# PLANNING & ZONING

**Planning and Zoning Commission -  
Plat Agenda**

**WRITTEN STATEMENT OF REASONS  
FOR CONDITIONAL APPROVAL OF A PLAT APPLICATION**

**Re:** Marrowbone Spring Park Addition, Final Plat

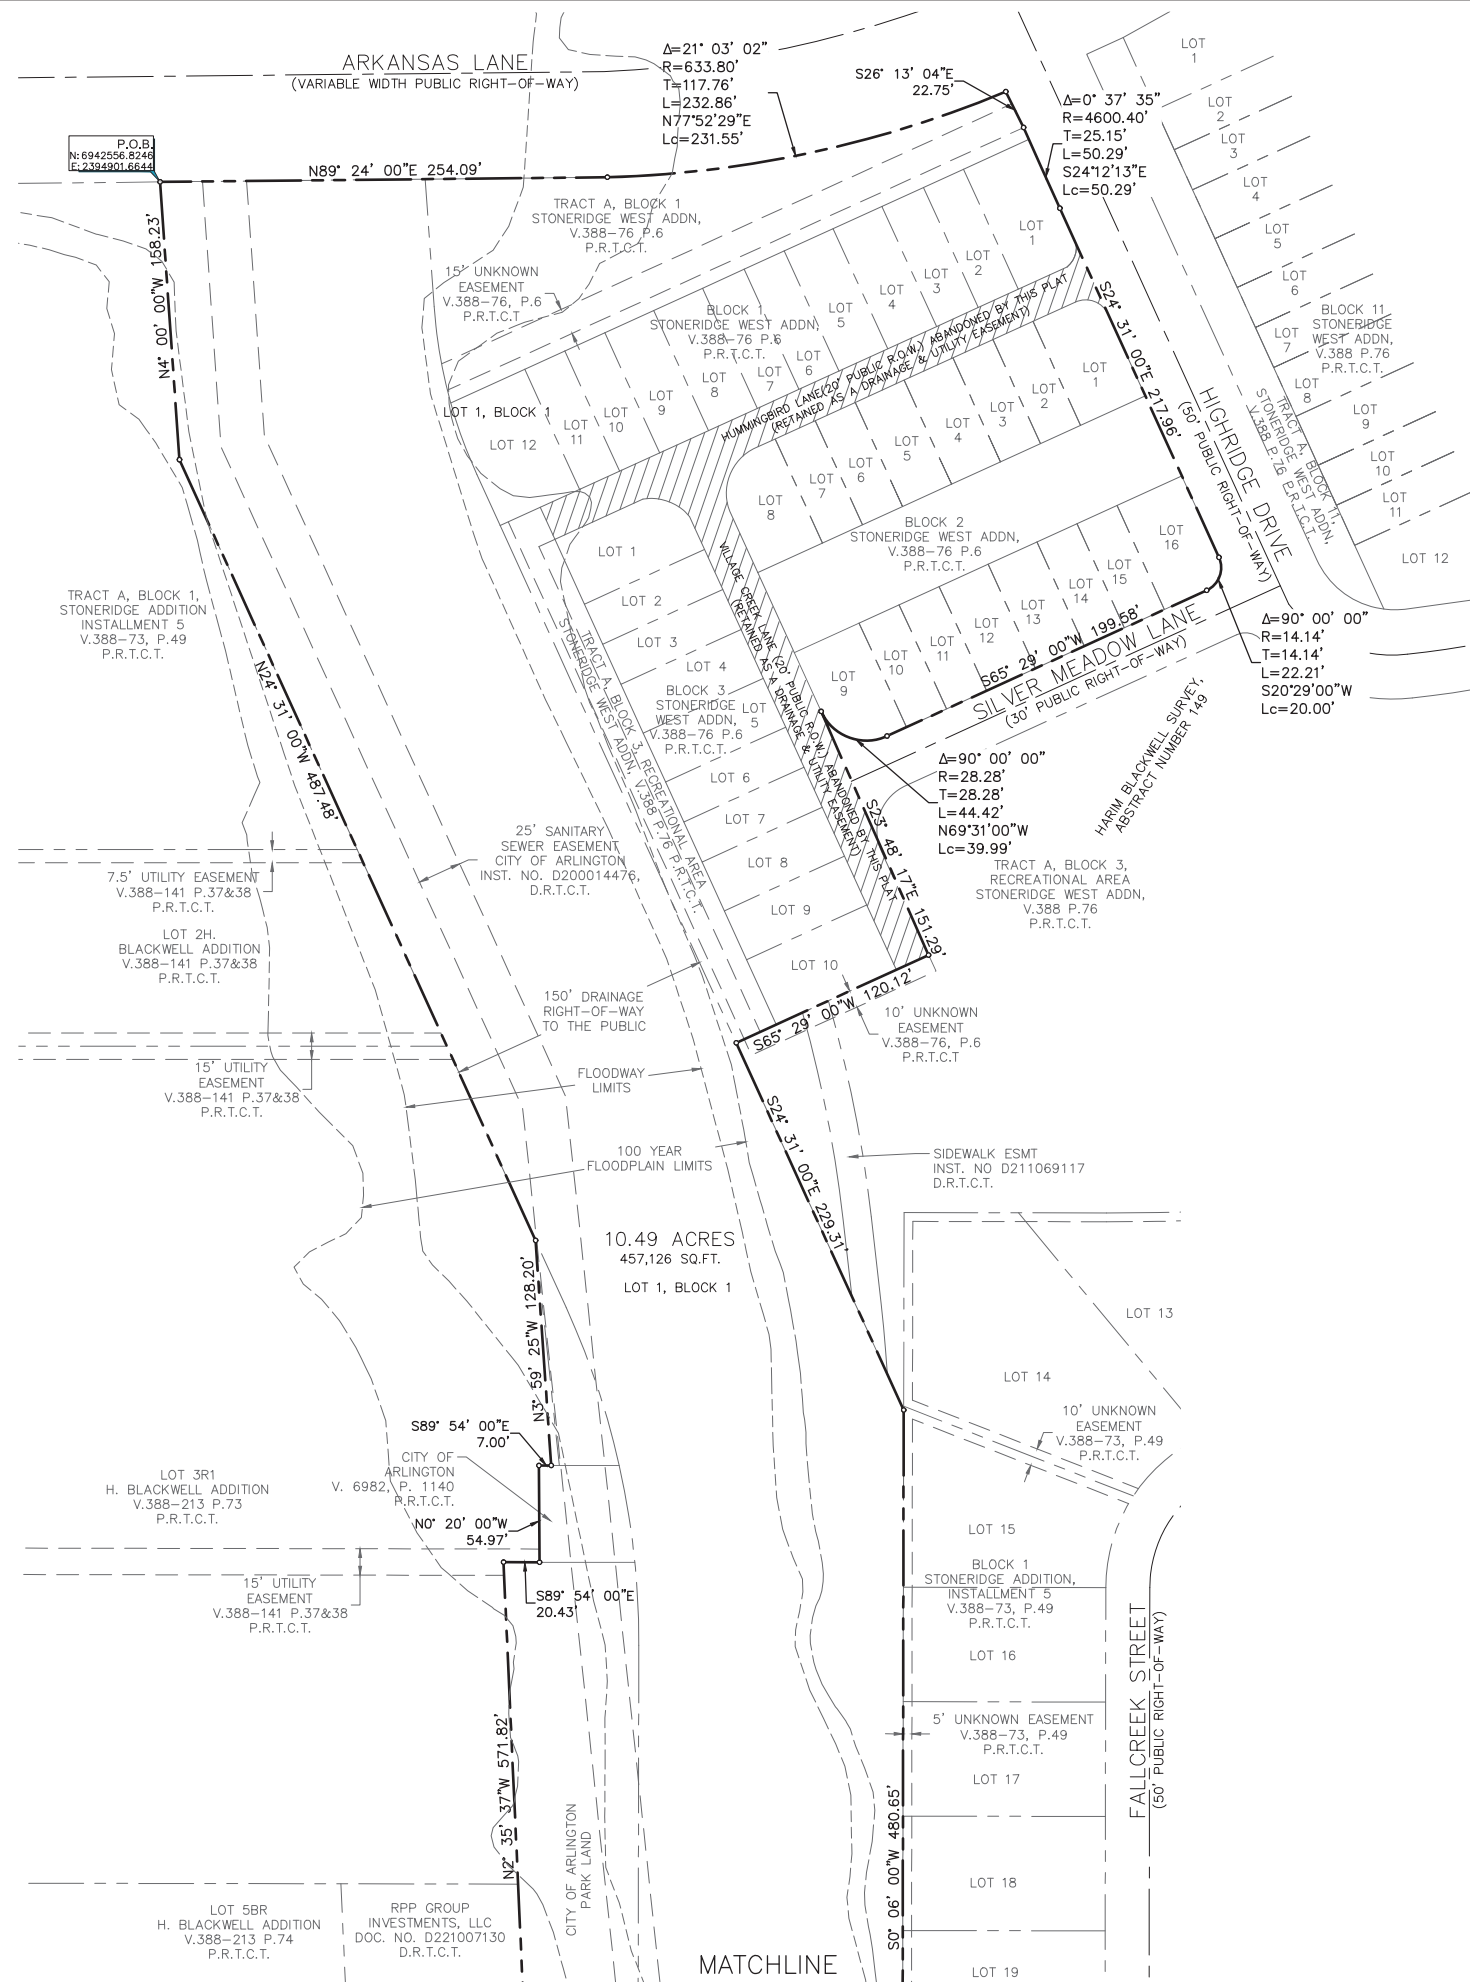
1. (Informational): Preliminary and Final Plats are subject to the criteria established in UDC Section 10.3.8, which includes compliance with use and development standards for the property as evidenced by an approved Site Plan(s). (UDC 10.4.14) The Site Plan and Final Plat are linked and shall match as to project scope. Complete Site Plan approval is contingent upon unconditional approval of the Final Plat. Site plans and other related plans will be reviewed during the Final Plat phase.

2. (Informational): Review the City's Unified Development Code (UDC) and other related documents to ensure the intended development is permitted and meets all requirements of the designated zoning district in which it is located.

3. (Informational): Any updated boundaries for the proposed plat will need to be included as part of the application package for the Final Plat submittal.

4. Include the following note on the face of the plat:

"Visibility Triangles shall be provided at the intersections of all public and private streets in accordance with City Ordinances. All landscaping (nothing over 2 feet in height as measured from the top of the curb) within the visibility triangles shall comply with the visibility triangle ordinance."  
(Standard Plat Filing and Formatting)

5. The Minimum finish floor shall be provided on the plat based in the latest FEMA study.
6. Based on the 100-year limit delineation on this plat, Stoneridge subdivision Lots 24, 25, 28, and 29 will laid within 100-year floodplain. It is important to provide a tie down of the floodplain limits.
7. Staff is awaiting a response from Oncor and comments may be generated once a response is received. If you have any questions, please contact Jim Conner, [jimmy.conner@oncor.com](mailto:jimmy.conner@oncor.com) Oncor Electric Delivery Co. LLC. 2005 S. Cockrell Hill Rd. Office 214- 330-2916 Cell. 817-470-6399 (Oncor comment)

8. The location of all existing or proposed fire lanes and fire hydrants needs to be shown on the plan documents.
9. (Informational): Fire lanes and access will need to meet the design requirements of our Design Criteria Manual at time of development. If shared access between lots will be needed, an agreement will need to be put in place. Fire lane/access per section 4.5.6 within the DCM. (Contact COA Engineering for process)

10. Add the prefix "WEST" or "W" to ARKANSAS LANE and TIMBERVIEW LANE.

11. A deed description shall be shown on the plat document.
12. The distance/direction calls on the deed description shall match the distance/calls on the plat boundary.
13. The plat boundary cuts off the lower area of Lots 9 through 16 on SILVER MEADOW LANE. Please verify the entire area of Lots 9 through 16 is included within the plat boundary.
14. Show the total acres to three significant digits.
15. Show the total acres below the plat title block.

**Re:** A.Newton Addition, Replat

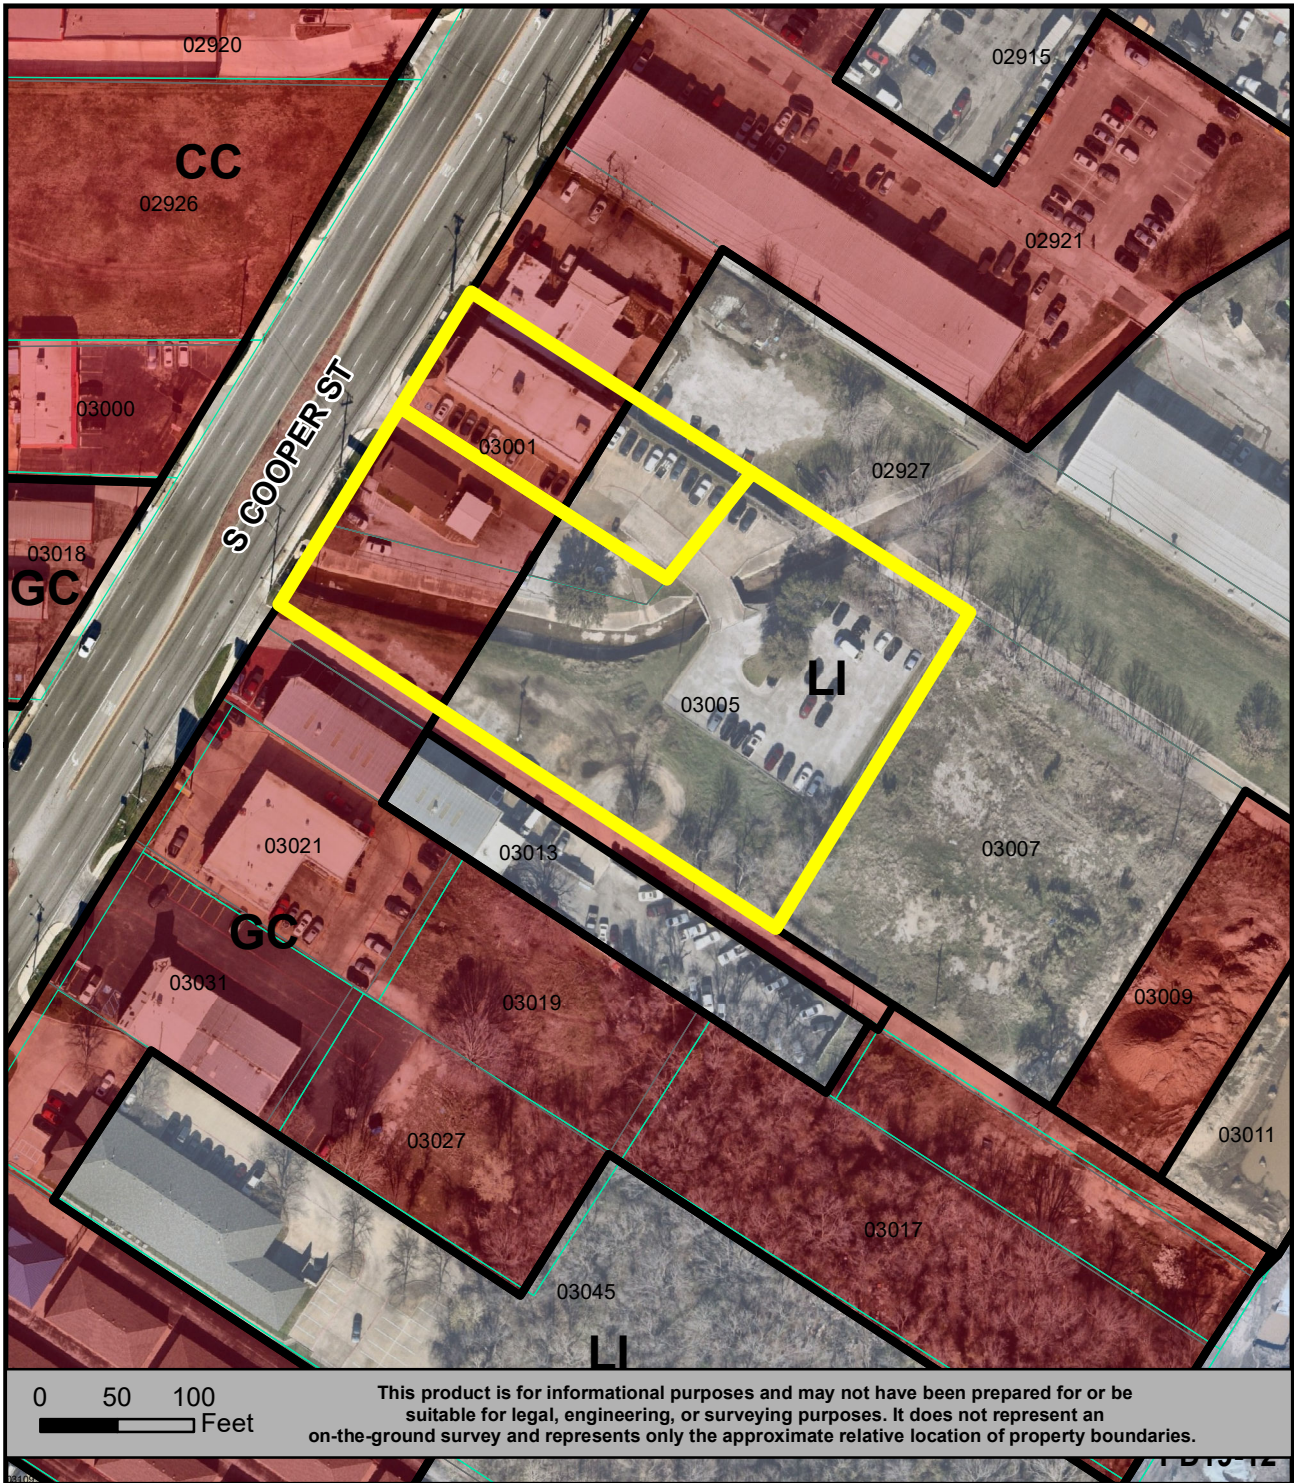
1. Some of the text is too bold to where the numbers and letters blend into themselves. All data shown on this plat shall be legible and reproducible. (Standard Plat Filing and Formatting)
2. Provide the name of the surveyor within the surveyor contact information. (Standard Plat Filing and Formatting)
3. Provide the following adjoining property information for 3009 South Cooper Street: Name of ownership with deed and recording volume and page. (Standard Plat Filing and Formatting)
4. This statement is only used when revising non-residentially zoned property. It should follow the Dedication Statement because the property owner is certifying the statement:

7. The following note should read as follows: This property may be subject to charges related to impact fees and the applicant should contact the City regarding any applicable fees due. (Standard Plat Filing and Formatting)
8. Staff is awaiting a response from Oncor and comments may be generated once a response is received. If you have any questions, please contact Joshua Brown, Joshua.Brown2@oncor.com Cell. 682-226-8977 (Oncor comment)

9. Specify if there is any new BMP installed, if not, the BMP maintenance statement on the plat can be removed.
10. If this is a new 24 ft shared access easement, include the following private access easement maintenance statement between these two lots on plat.

11. Please label the street segment "Public" or "Private" Right-of-Way.

12. The plat shall include GPS coordinates for the Point of Beginning in U.S. feet, State Plane GRID Coordinate System (NAD83) - Texas North Central Zone (4202). Provide scale factor if applicable.
13. Show on the plat any pipeline petroleum product easement within 200 feet of the parcel boundary.

14. The location of all existing or proposed fire lanes and fire hydrants needs to be shown on the plan documents.
15. (Informational): Fire lanes and access will need to meet the design requirements of our Design Criteria Manual at time of development. If shared access between lots will be needed, an agreement will need to be put in place. Fire lane/access per section 4.5.6 within the DCM. (Contact COA Engineering for process)

## **Preliminary Plat (H.D. Thompson Addition)**

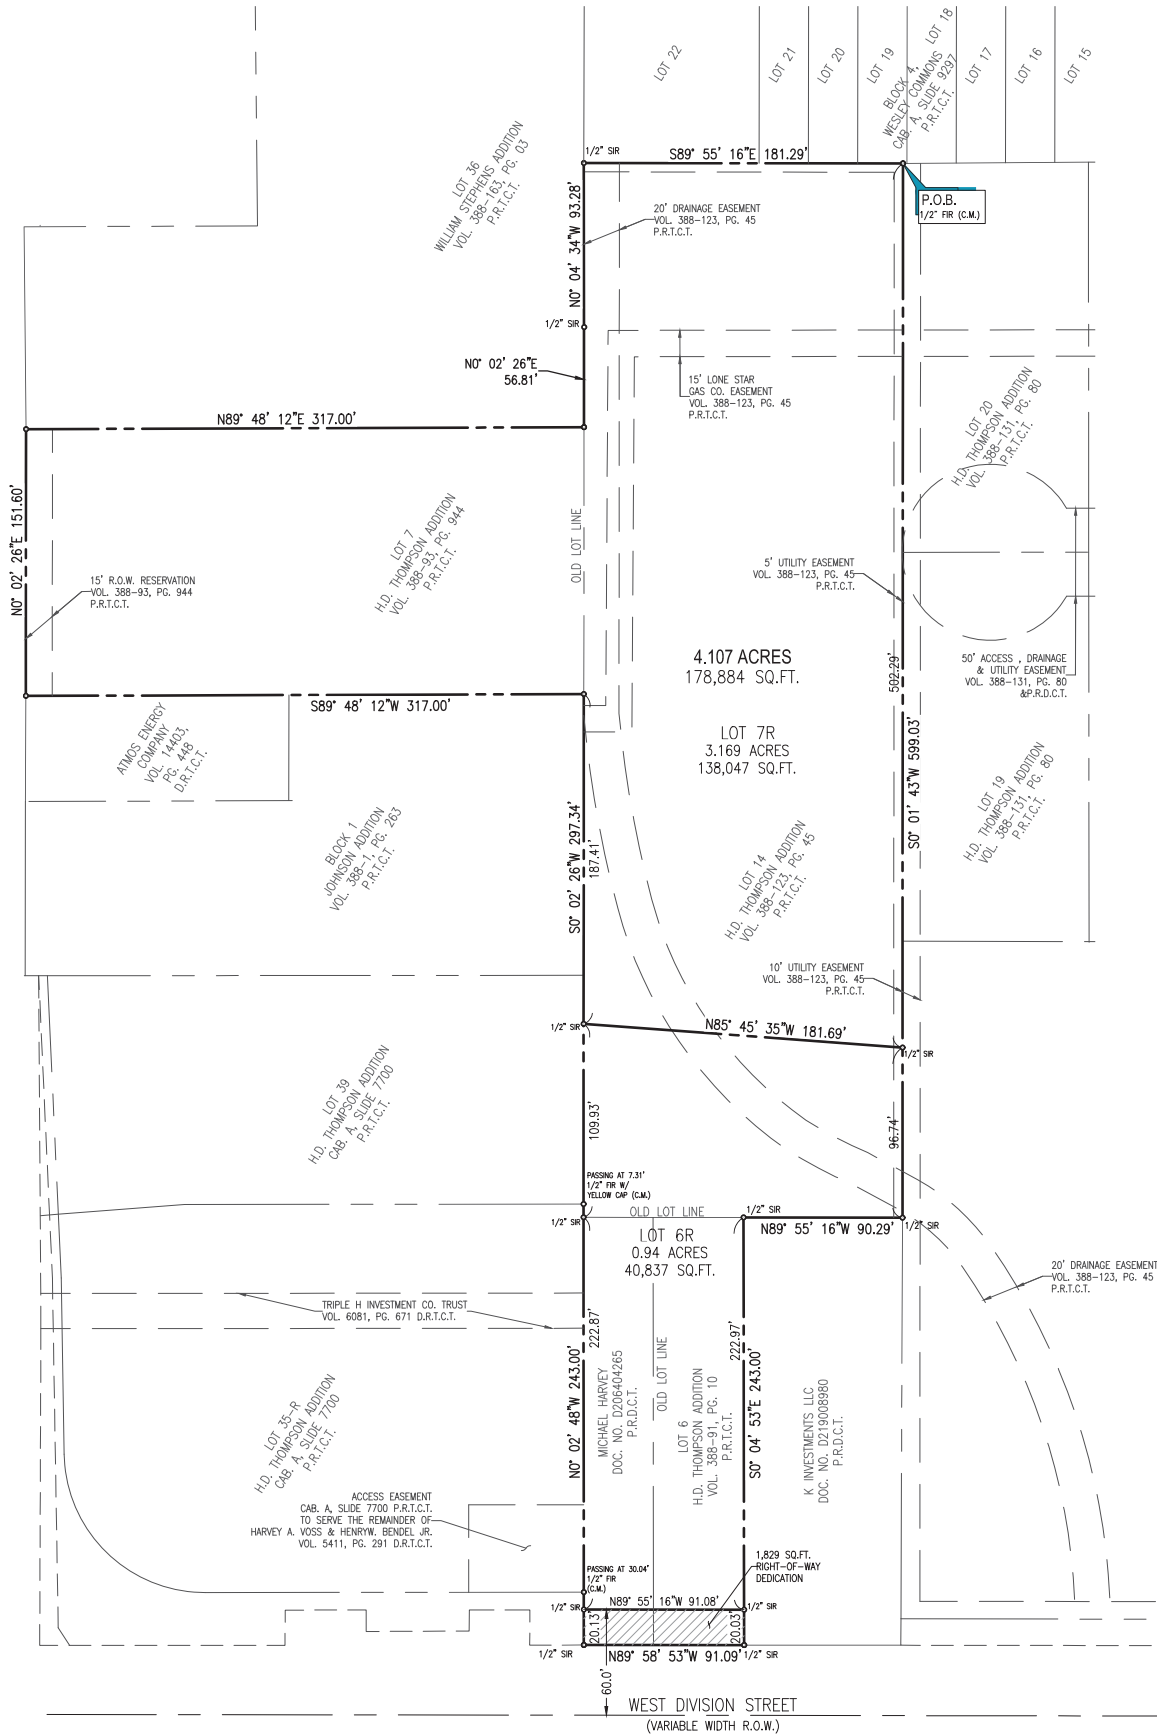
2. Provide an owner certification and disclosure of interest page for each of the five property owners. (Standard Plat Filing and Formatting)  
Add the Surveyor's name to the surveyor contact information at the bottom of the plat. (Standard Plat Filing and Formatting)

5. The drawing should clearly depict the location and approximate dimensions of all boundary lines (indicated by heavy lines) to the nearest foot. (Standard Plat Filing and Formatting)

8. Add Harvey S. El-Etoun as one of the owners of 2423 W Division Street. (Standard Plat Filing and Formatting)
9. Your lot line measurements are significantly off from my approximate measurements: Please check the following measurements: The northern and southern property lines at 343 N Bowen Rd are shown as 317ft, but I am measuring approximately 305ft. The property line going north from the northeast corner of 343 N Bowen Rd is shown as 93.28ft, but I am measuring approximately 148 ft. The longest eastern property line for the subject site is shown as 599.03ft, but I am measuring approximately 608ft. (Standard Plat Filing and Formatting)

10. 2344 Kingsway Dr is shown to be too wide. Per your scale, it's 100ft wide, but I am measuring 70ft. (Standard Plat Filing and Formatting)
11. Informational: At the time of final plat, provide a notarized affidavit or add the following language to the face of the plat following the Dedication Statement: "Pursuant to Section 12.002 of the Texas Property Code, as amended, I have obtained original tax certificates from each taxing unit with jurisdiction over each parcel of real property in said subdivision indicating that no delinquent ad valorem taxes are owed on the real property which is the subject of the plat or replat I have submitted to the City of Arlington, Tarrant County, Texas for filing and recording with the Tarrant County Clerk's office." (Standard Plat Filing and Formatting)

20. Add the following note to the plat: Visibility Triangles shall be provided at the intersections of all public and private streets in accordance with City Ordinances. All landscaping within the visibility triangles shall comply with the visibility triangle ordinance. (Standard Plat Filing and Formatting)

22. Please add AMANDA No. 2024 002691 to the face of the plat.
23. Include recording information for detention basin easement on the face of the plat.
24. Include maintenance statement on the face of the plat. Email don.harrelson@arlingtontx.gov for maintenance statement.
25. Repair existing channel to match approved cross section.
26. Existing channel no longer matches easement alignment.

28. The plat shall include GPS coordinates for the Point of Beginning in U.S. feet, State Plane GRID Coordinate System (NAD83) - Texas North Central Zone (4202). Provide scale factor if applicable.
29. Show on the plat any pipeline petroleum product easement within 200 feet of the parcel boundary.

30. The location of all existing or proposed fire lanes and fire hydrants needs to be shown on the plan documents.
31. Informational: Fire lanes and access will need to meet the design requirements of our Design Criteria Manual at time of development. If shared access between lots will be needed, an agreement will need to be put in place. Fire lane/access per section 4.5.6 within the DCM. (Contact COA Engineering for process)
